Playground equipment for children - Part 1: Replies to requests for interpretation of EN 1176:2017 and its parts (2018-2019)

FINAL DRAFT FprCEN/TR 17842-1

4.1 General (interpretation request 2018-01 — Norway)

https://standards.iteh.ai/catalog/standards/sist/b732efa0-ebaf-4030-bab2-e601a21350d7/ksist-tr. **Figure 2**r-17842-1-2022

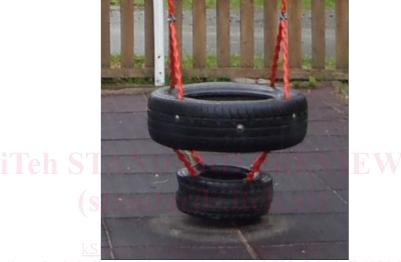
This is regarding double tyre swing seats. These seats consist of one big car-tyre that has a smaller tyre (often called security tyre) hanging under it – see Figure 2 below.

The new standard does not include information on ground clearance for tyre seats as in the previous edition. Instead there is a description for single user seat with ground clearance 35 and group swing seat with clearance demand 40.

What seat type does the standard define, a single tyre seat or a double tyre seat as shown in Figure 2 below; single user seat or group swing seat?

In the case of double tyre seat – see Figure 2 below, is the ground clearance demand applicable only for the main top tyre or for the lower tyre as well?

NB – we often observe children standing on the lower tyre having the upper tyre supporting their body. This has the effect that the lower tyre will not easily deflect if it hits or squeezes another child under it

against the impact attenuating surface (IAS) under the swing as many seem to argue so that they can justify that the ground clearance should only be measured from the top tyre.

Sentence 2 in the clause does not define where this measure is to be taken, and one presumes that this is where the seat is closest to the IAS. Is this correct?

Sentence 3 deviates from sentence 2 for the part of swings being flexible. Is this to be seen in conjunction with sentence 2 so that IF a part of a seat is flexible this part shall not be included for measurement of ground clearance? (This would be easier to understand and see if both sentences were included in the same sentence or paragraph.)

NB! – Here also we do see that flexible lower parts of seats, often with many children inside will not necessarily deflect or prevent a child falling off the seat in the possibility to be squeezed under the seat against the IAS.

No action/interpretation

This type of swing seat is not specifically covered in EN 1176.

We would recommend that a future work request is made by the NSB if they feel there is a strong requirement to start future work on products of the type shown following the procedure agreed by SC1 (see template in document SC1 N9002). This is to encourage the use of the template / matrix, and to avoid duplication of work.

For information we can confirm that:

This type of seat is special as it has a top section that provides a general sitting position and also has a lower flexible part that would only provide a sitting position to very young children, who had their body positioned within the top section. Prior to publication of EN 1176 swing seat ground clearances were referenced in DIN 7926-2. This publication required a ground clearance of 250 mm for seats less than 1 000 g in weight. Although this old standard is no longer valid, the information could be used as part of a risk assessment on the lower seat part.

In addition to the specific requirements of EN 1176, it is always recommended that a risk assessment is carried out should unusual situations be identified.
